LEWIS COUNTY PUBLIC SAFETY BUILDING PARKING LOT AND DRAINAGE PROJECT

REVISIONS		
NUMBER	DESCRIPTION	DATE
△	ADDENDUM #1 - SEE INDIVIDUAL SHEETS FOR ALTERATIONS	05-11-2023

2023-003 - MAY 3, 2023
LEWIS COUNTY PUBLIC SAFETY BUILDING
PARKING LOT AND DRAINAGE PROJECT
VILLAGE OF LOWVILLE, LEWIS COUNTY, STATE OF NEW YORK

LAST REVISED: 05-11-2023
CONSTRUCTION DOCUMENTS
DRAWING NO.
C106

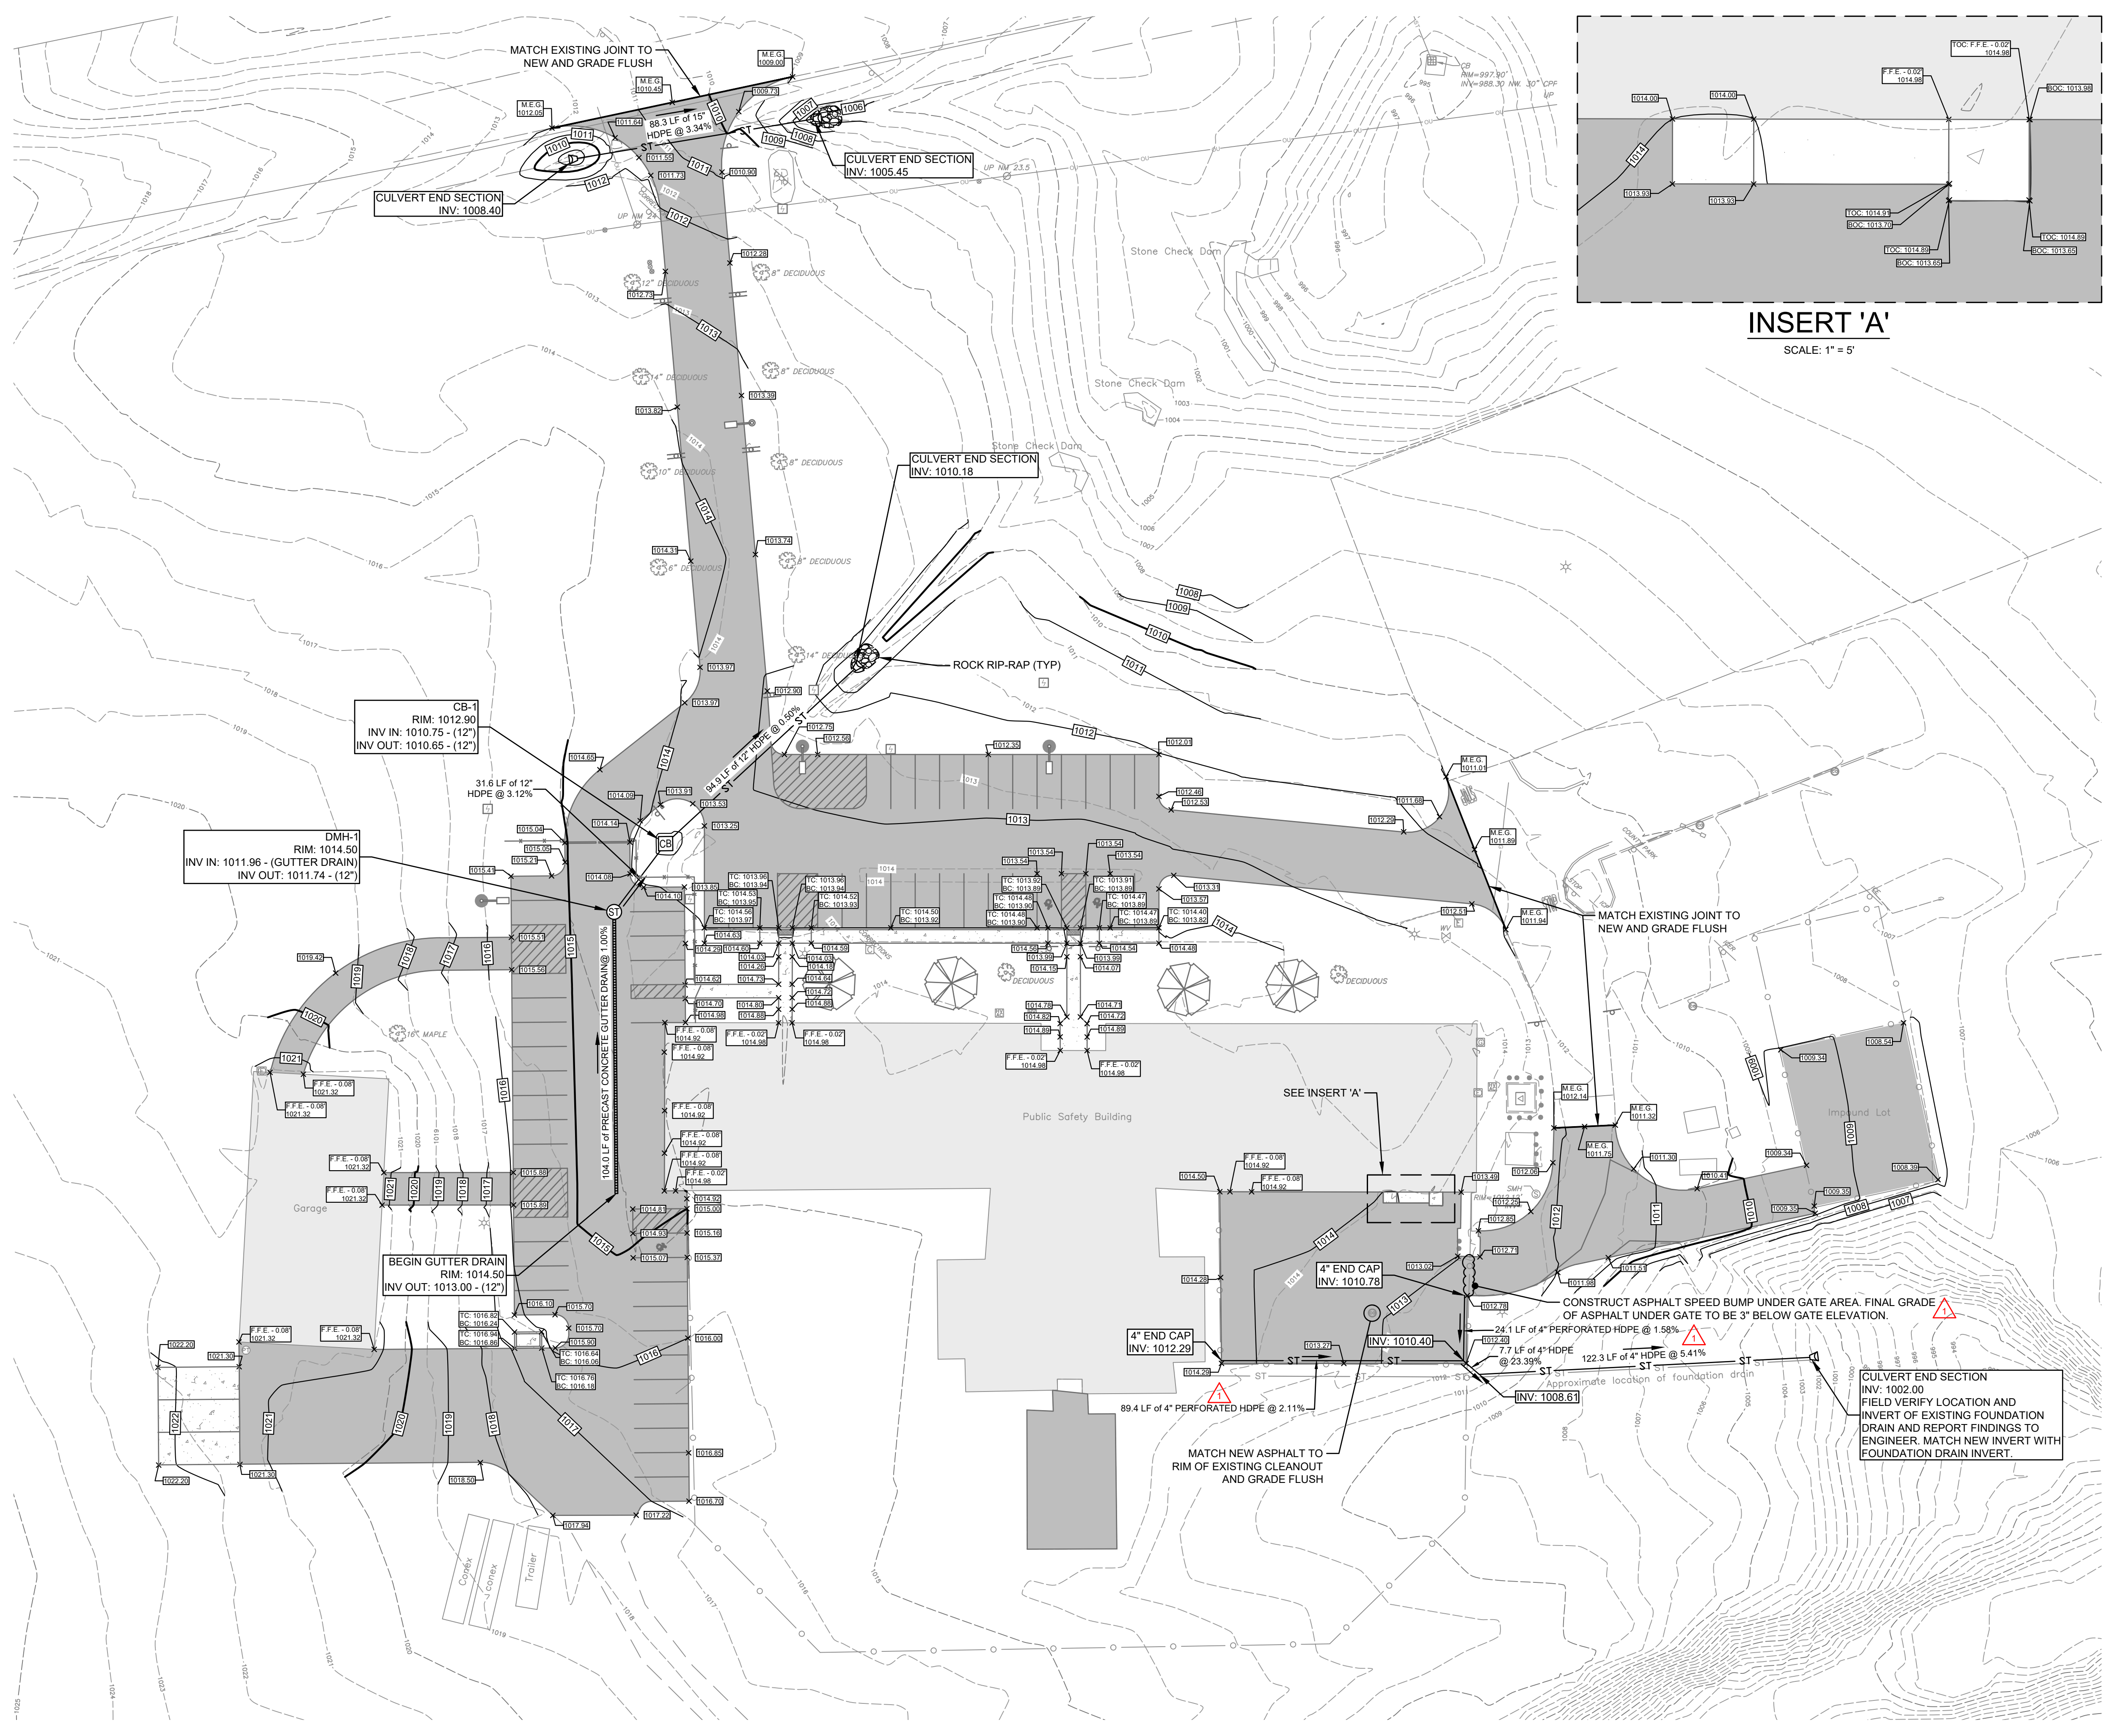
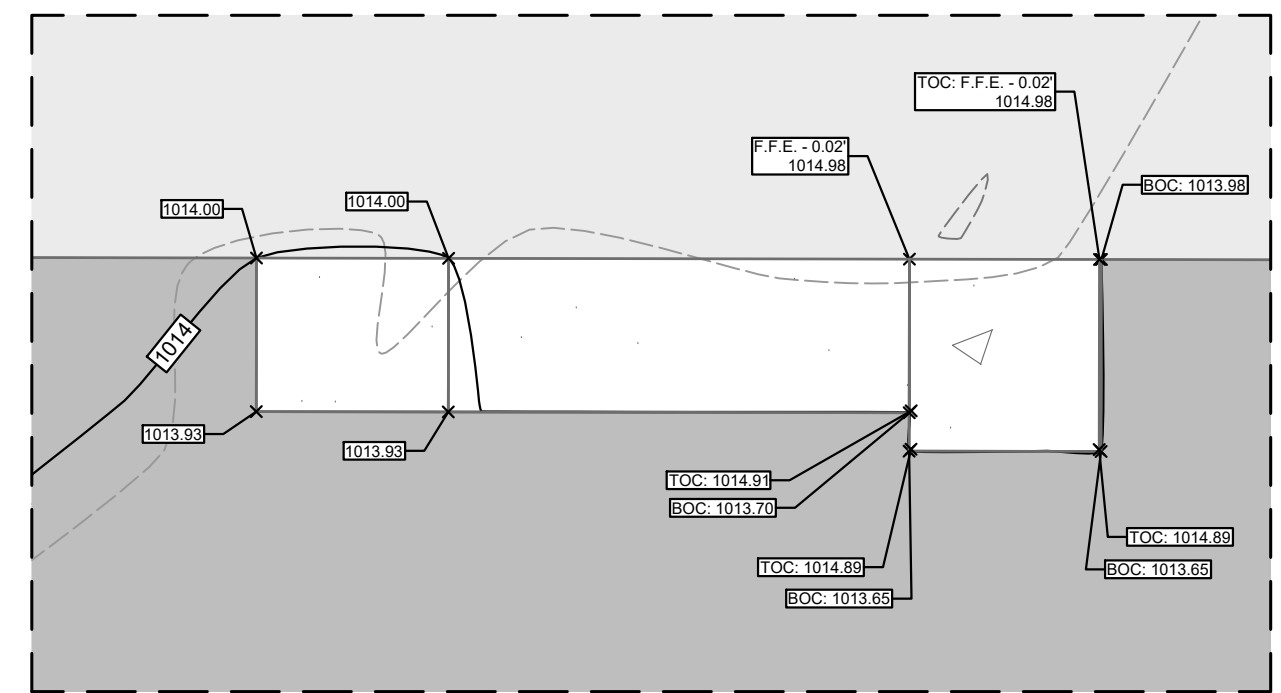
REVISIONS		
NUMBER	DESCRIPTION	DATE
1	ADDITION OF UNDERDRAIN AND SPEED BUMP IN SALLYPORT	05-11-2023

DRAWING NO. **C107**

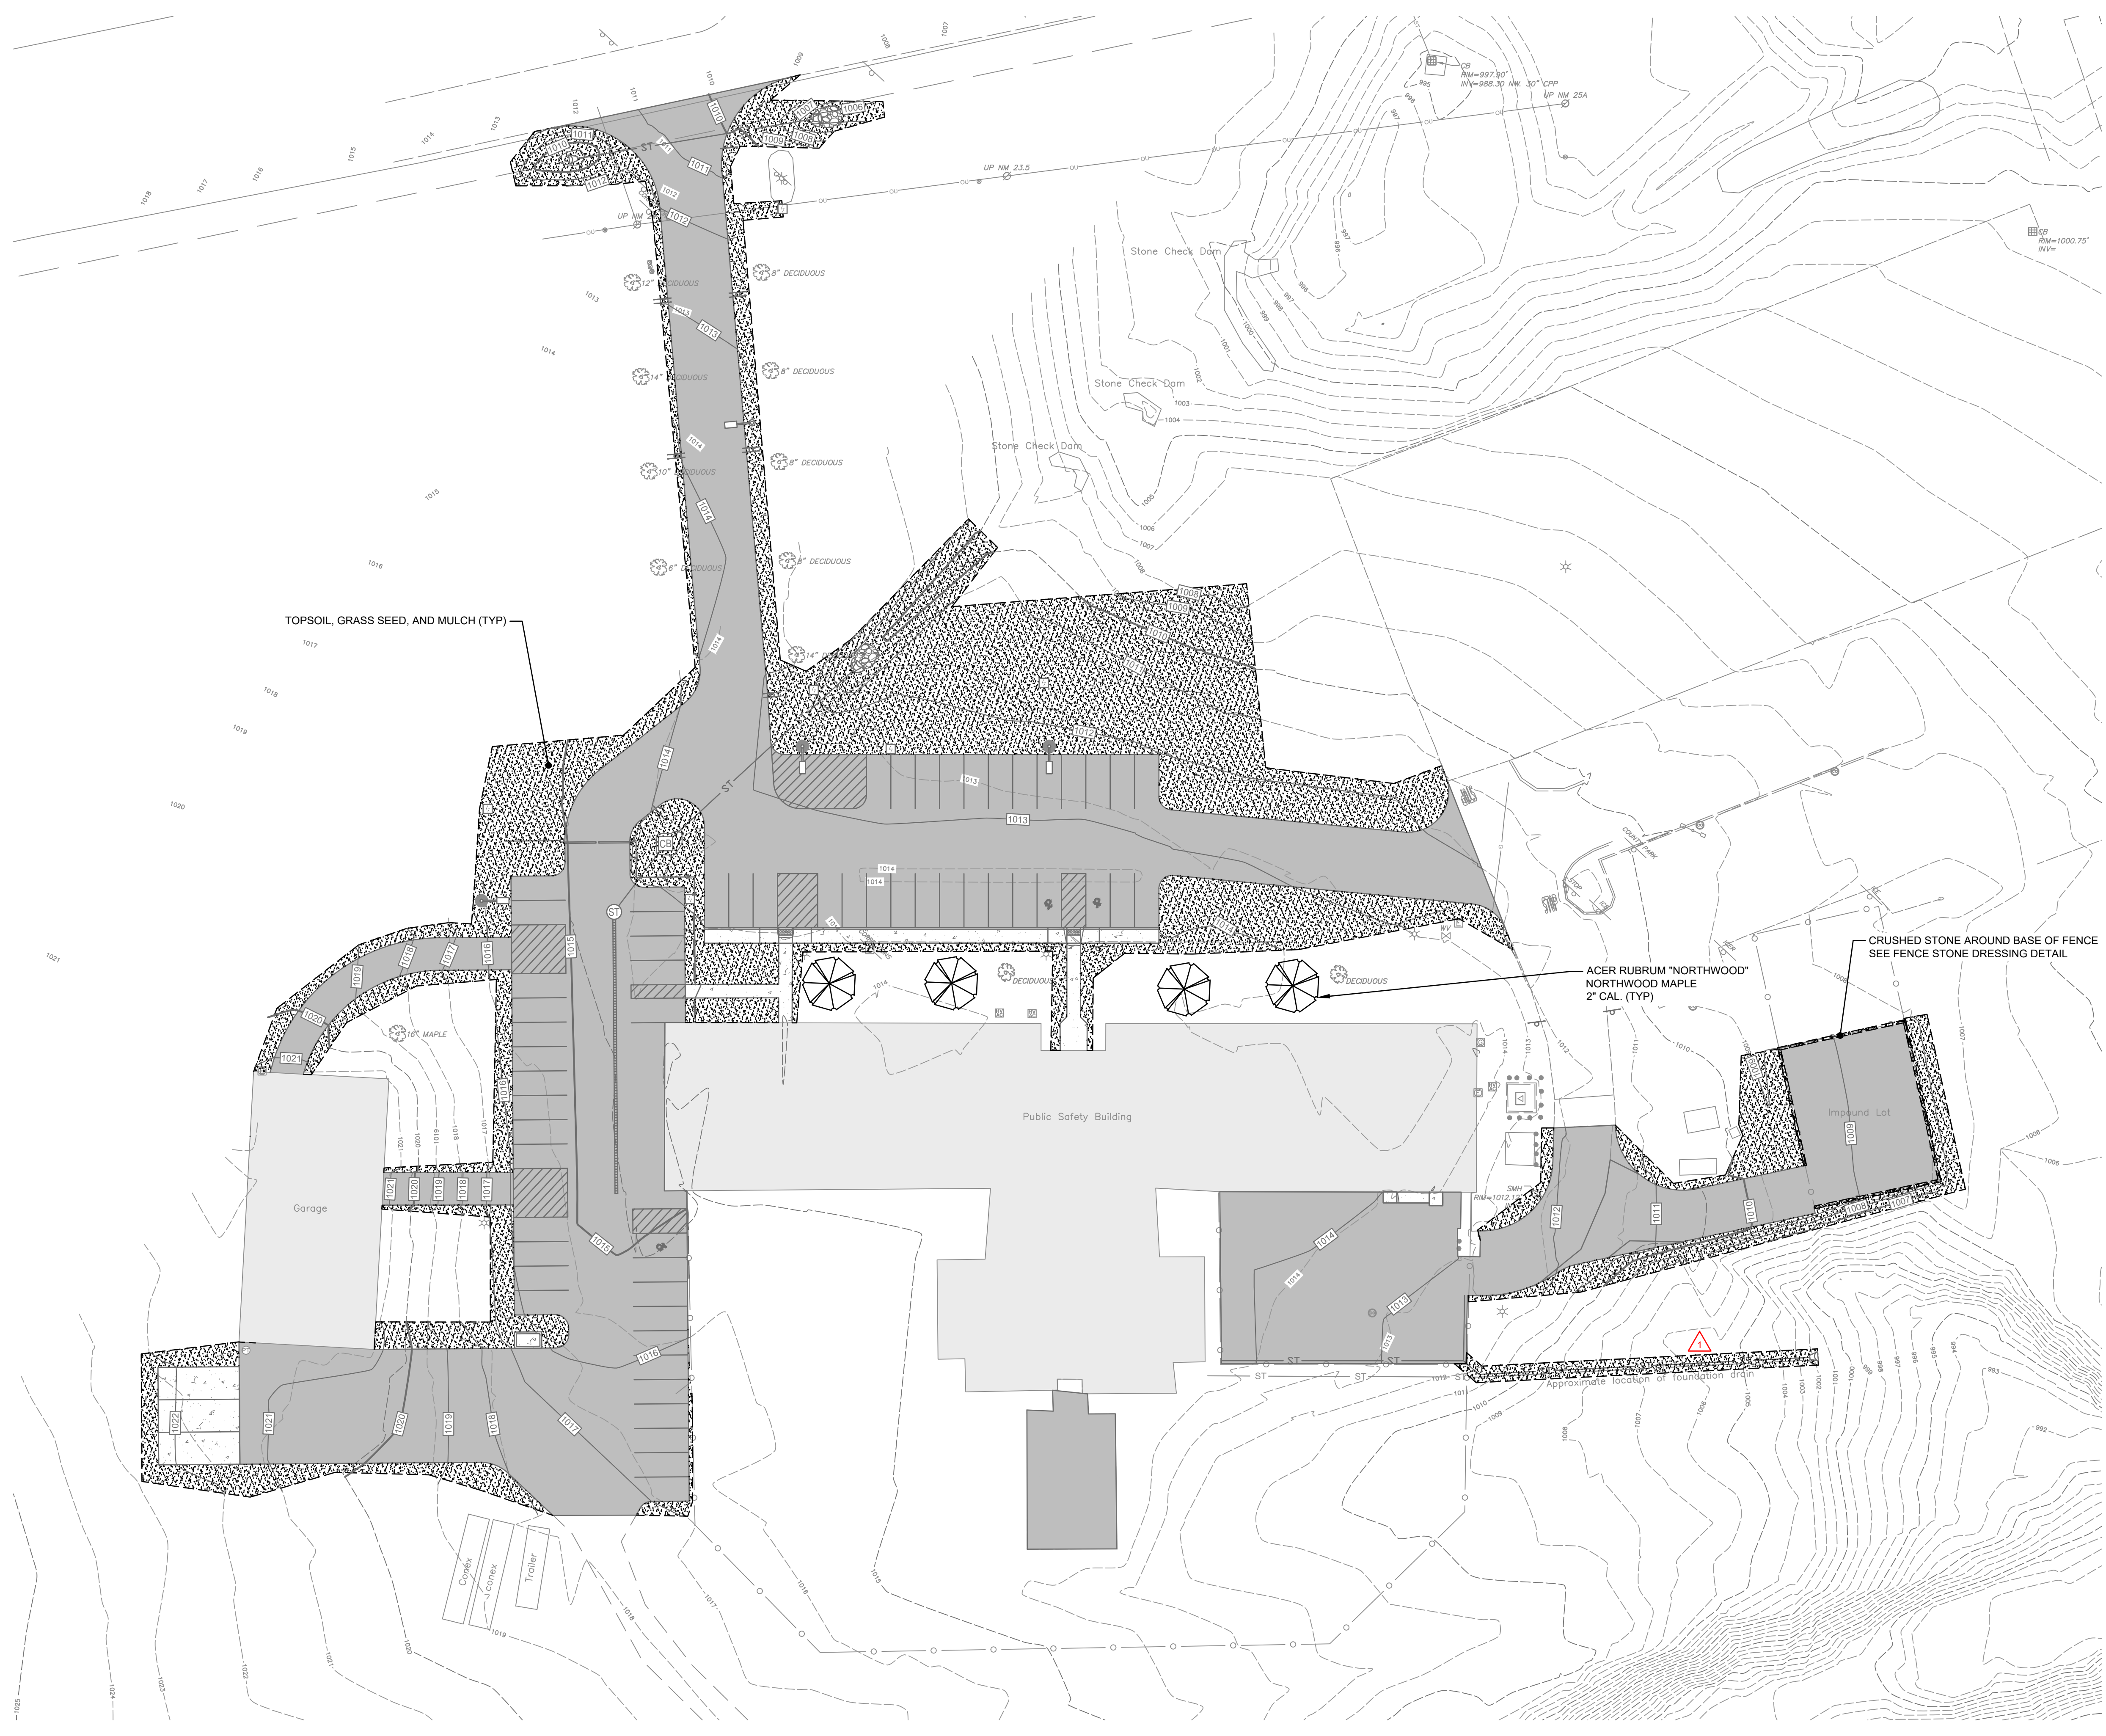
REVISIONS		
NUMBER	DESCRIPTION	DATE
	ADDITION OF LANDSCAPING ASSOCIATED WITH SALLYPORT UNDERDRAIN INSTALLATION	05-11-2023

4 TYPICAL ASPHALT PAVEMENT DETAIL
C501 NOT TO SCALE D153-01

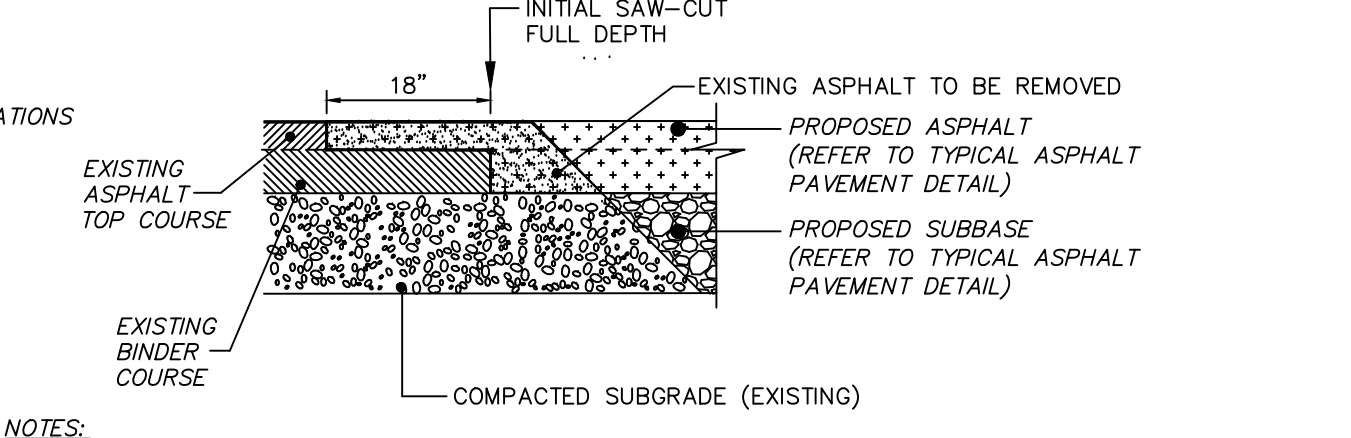
REVISIONS		
NUMBER	DESCRIPTION	DATE
△	ADDITION OF TACK COAT TO DETAIL 4/C501	05-11-2023
